STAFF RECOMMENDATION 0 Murphy Road (Acklen Park Drive) March 15, 2017

Application: New construction – infill (two duplex lots)
District: Richland-West End Addition Neighborhood Conservation Zoning Overlay
Council District: 24
Map and Parcel Number: 10405006500
Applicant: Patrick Chisholm, Vandy Acklen Park LLC
Project Lead: Sean Alexander, sean.alexander@nashville.gov

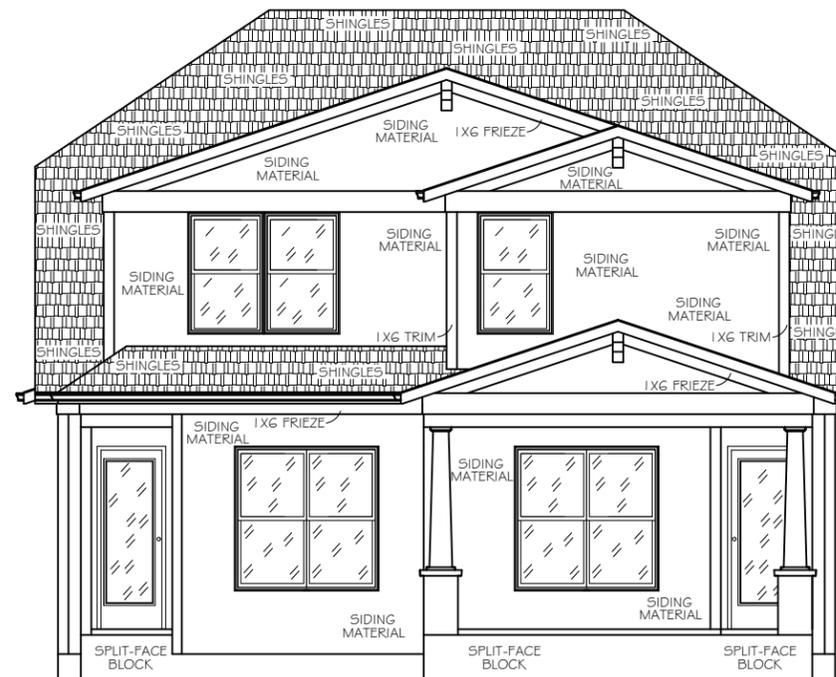
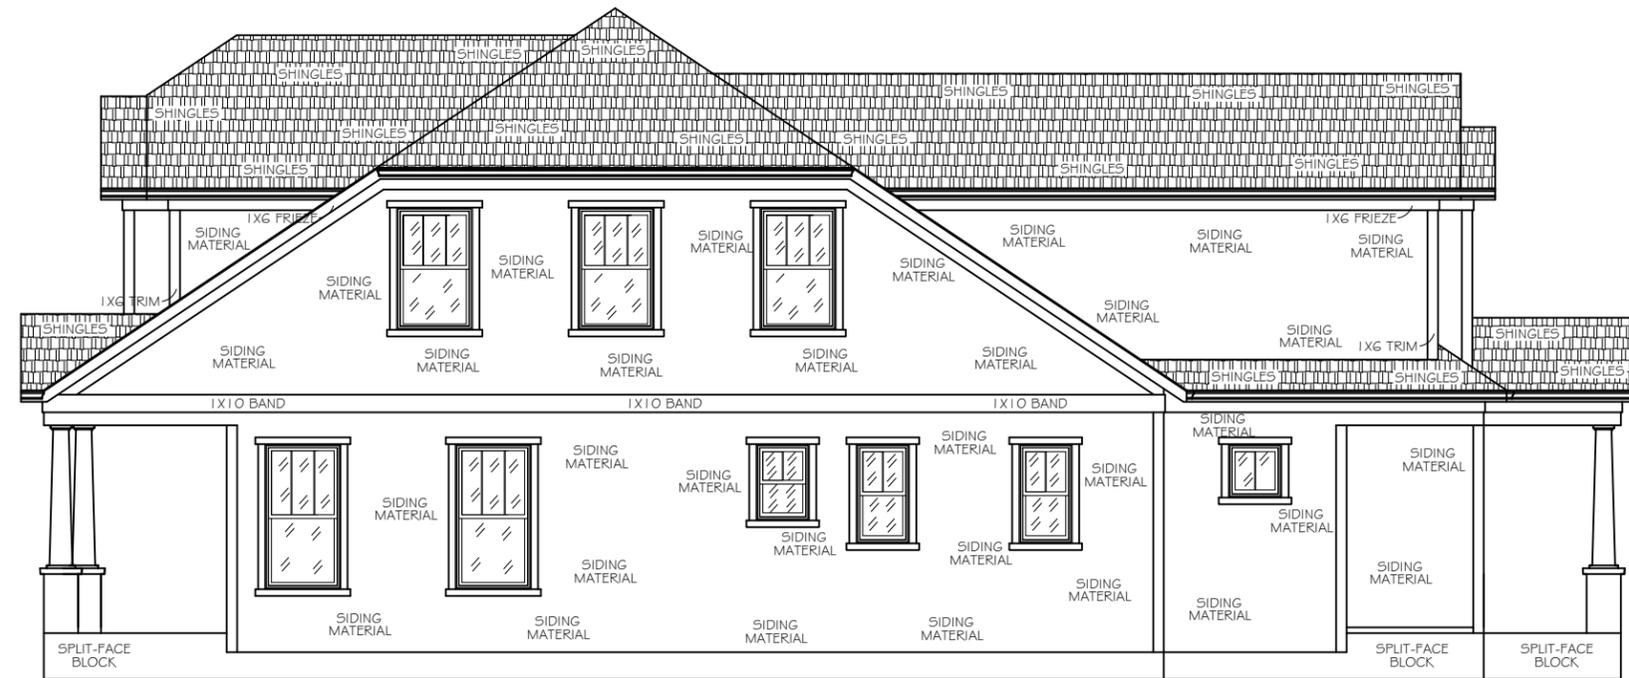
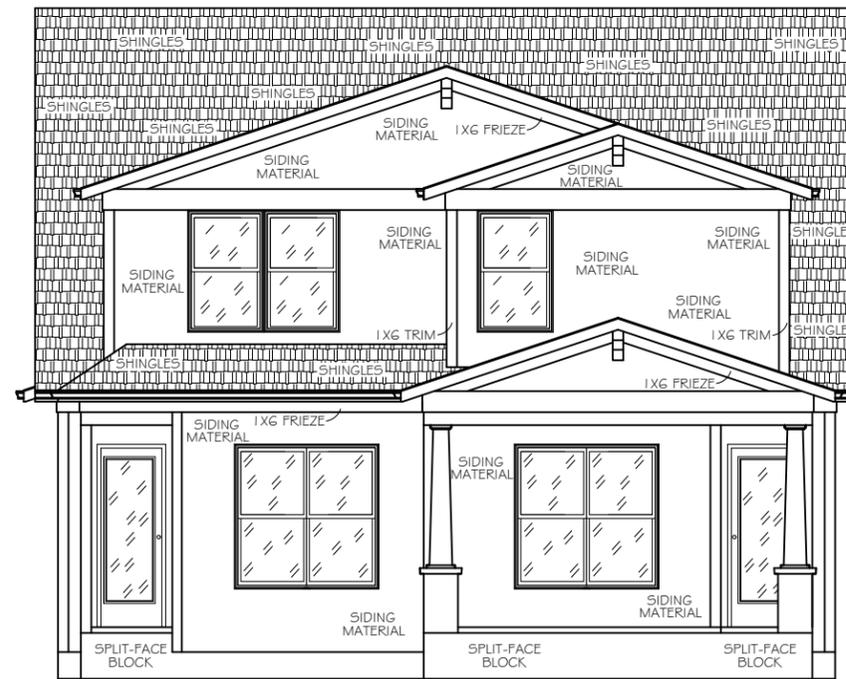
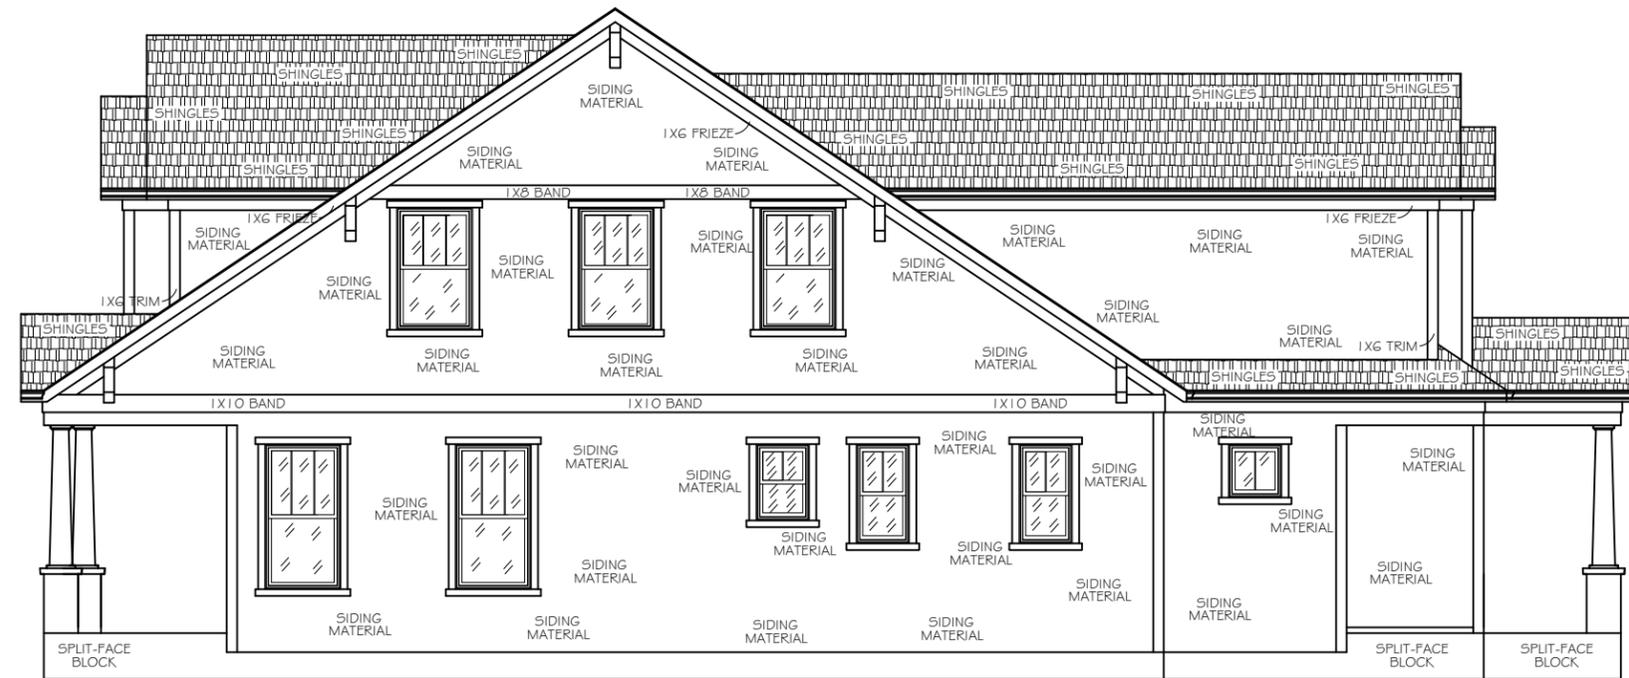
The topography of the property appears to slope down to the left, which is not clearly depicted on the elevations. Staff asks that the elevations are revised to show the foundation height and to inspect the foundation heights during construction to verify that the floor levels are consistent with the context.

The primary roof forms and pitches are commonly found on historic houses throughout the neighborhood, as are the forms and pitches of the porches. Nested gables, however, are not a feature found on historic buildings in the surrounding area. Staff recommends that the dormers be simplified to be more like those on historic houses. With that revision, Staff finds that the project would meet section II.B.1.e of the design guidelines.

1. The elevations shall be revised to accurately reflect the grade of the lots and foundation heights;
2. Staff shall inspect the foundation heights during construction to verify that the floor levels are consistent with the surrounding context;
3. The front dormers shall be revised to a form more typical of the historic context;
4. The siding reveals and textures, roof colors, windows, doors, and other materials not known shall be administratively approved prior to permitting;
5. Walkways are added to lead from each porch to the sidewalk; and
6. The materials of all paving shall be approved by Staff and the HVAC shall be located on the rear façades or on side façade beyond the midpoints of the houses.
